**UTAH DIVISION OF RADIATION CONTROL
ENERGYSOLUTIONS LLRW DISPOSAL FACILITY
CLASS A COMBINED AMENDMENT REQUEST**

SAFETY EVALUATION REPORT

August 25, 2006

Figure 4. Environmental Monitoring and Sampling Locations for CAC cell

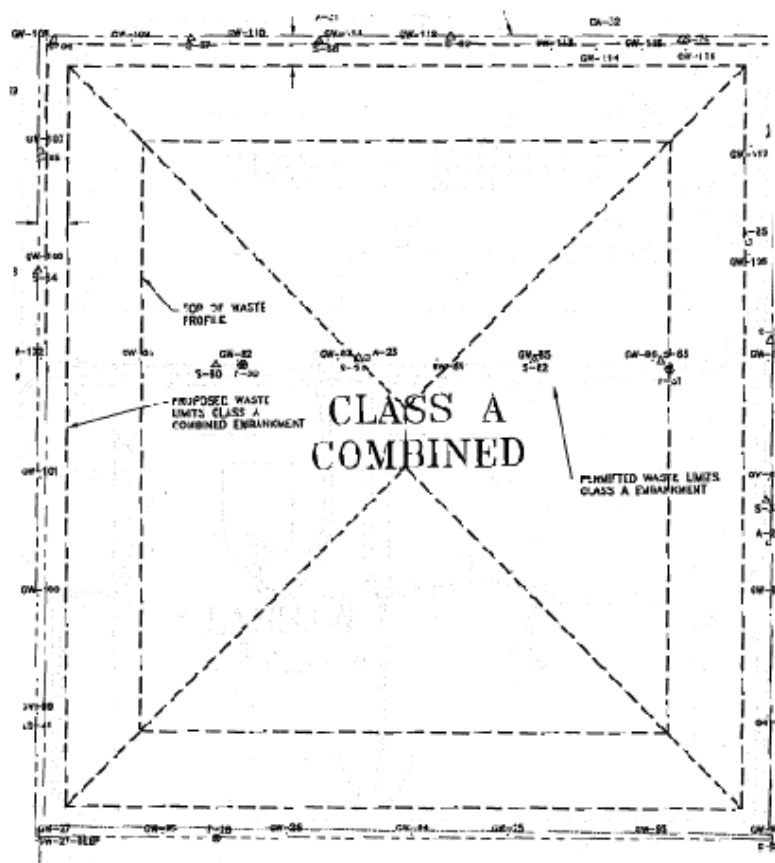
The Licensee states in the EJR that the monitoring network fits within the buffer zone, contaminants would not reach the monitoring wells for at least 500 years (EnergySolutions 2006a Section 3.5.1). Also, the majority of plans and procedures as a whole are largely unaffected by the permitting of the CAC cell (EnergySolutions 2006a, Introduction) and refers to the documents submitted with the 2005 LRA (Envirocare of Utah LLC 2005b). Construction of the CAC cell will remove some monitoring locations as they fall within the footprint of the Class A and CAN cells (EnergySolutions 2006a, Figure 05054 U02). An excerpt of Figure 05054 U202 is shown in Figure 4.

The environmental monitoring plan will require modification to remove the above locations that would otherwise be inside the footprint of the proposed CAC cell. No changes to the analytical suites, matrices, or sampling/monitoring frequency are required or anticipated.
